RAMONA-ALESSANDRO ELEMENTARY SCHOOL
MODERNIZATION
670 RAMONA AVENUE
SAN BERNARDINO, CA 92411

NO.	REVISIONS	DATE	NO.	REVISIONS	DATE
1	DSA ADDENDUM NO. 1	2/10/10

REMODELED FLOOR PLAN 'A' WING-EAST

DESIGNED MRath	PROJECT NO. 3137117
DRAWN MMinamide	SCALE 1/8"=1'-0"
CHECKED QC	DRAWING NO. 1 AA2.3
DATE 19 MAR 2004

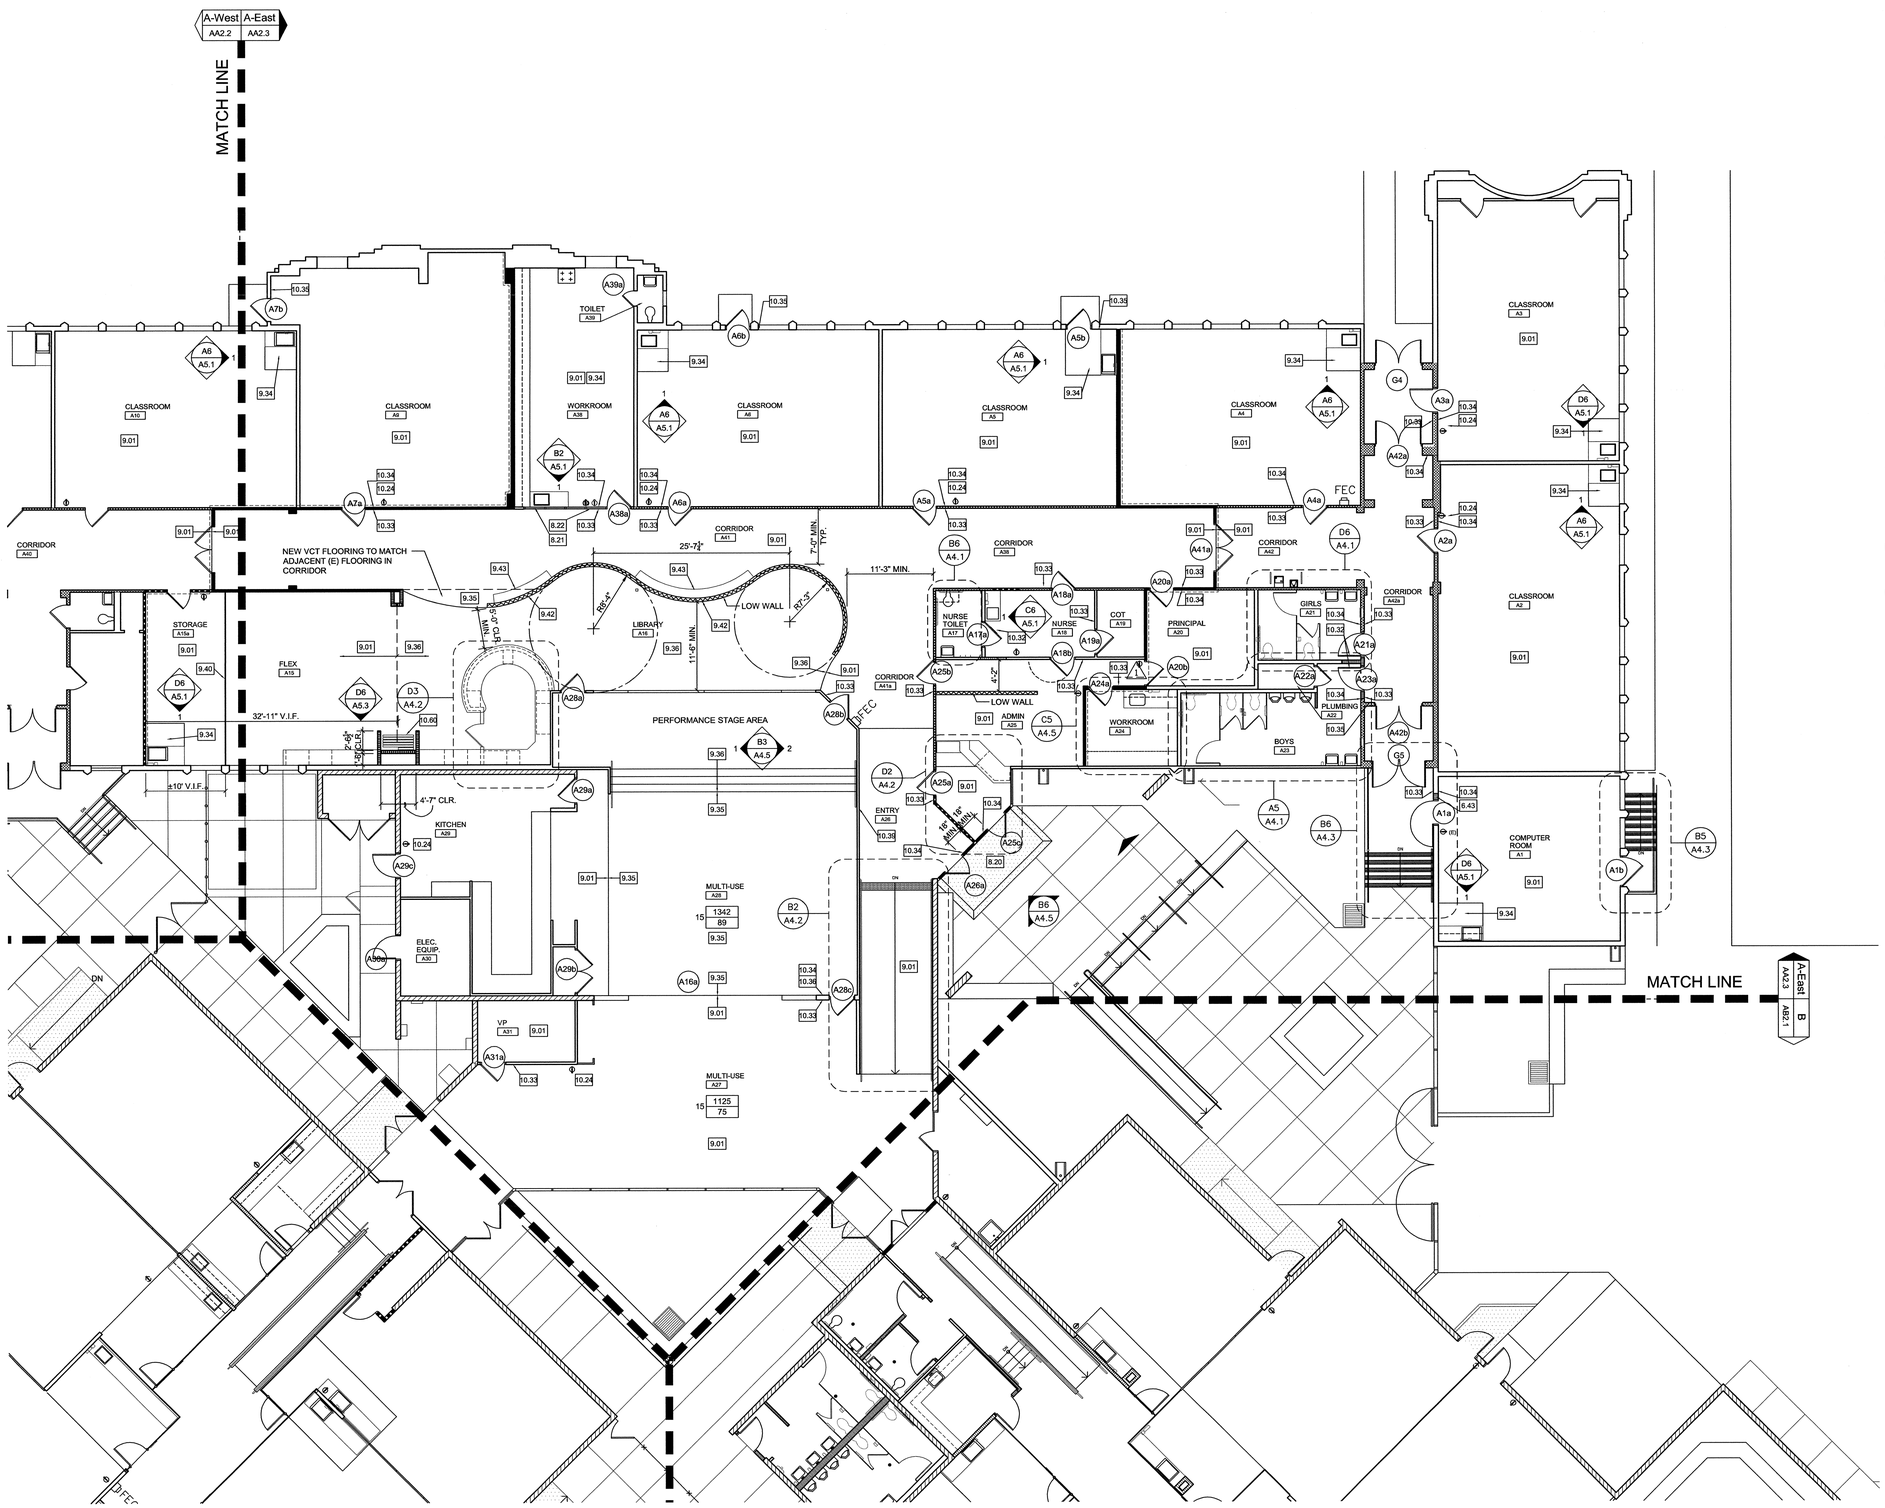
Note:
CONTRACTOR TO FEILD VERIFY
45-MINUTE RATED GLAZING UNIT SIZES.
IF INDIVIDUAL PANE EXCEEDS 1296 SQ. IN.
CONTRACTOR IS REQUIRED TO PROVIDE A
"FIRELITE" 45 MIN. RATED
GLAZING UNIT.

8.21 CONTRACTOR TO HAVE GLAZING TESTED AND RECERTIFIED FOR A 45 MIN. FIRE RATING
1 8.22 REPLACE (E) GLAZING WITH WIRE GLASS
8.23 (N) DOOR OPENING, FRAME PER DTL 1 S1.2

9.35 VINYL COMPOSITION TILE AND TOPSET BASE
9.36 CARPET AND TOPSET BASE
1 9.40 NEW DEMOUNTABLE WALL PARTIONS PER DTL C3/A9.4
9.41 EXISTING DEMOUNTABLE WALL PARTITIONS TO REMAIN
1 9.42 36" DIVIDER WALL W/ DECORATIVE PLASTIC LAMINATE FINISH PER DTL D5/A9.4
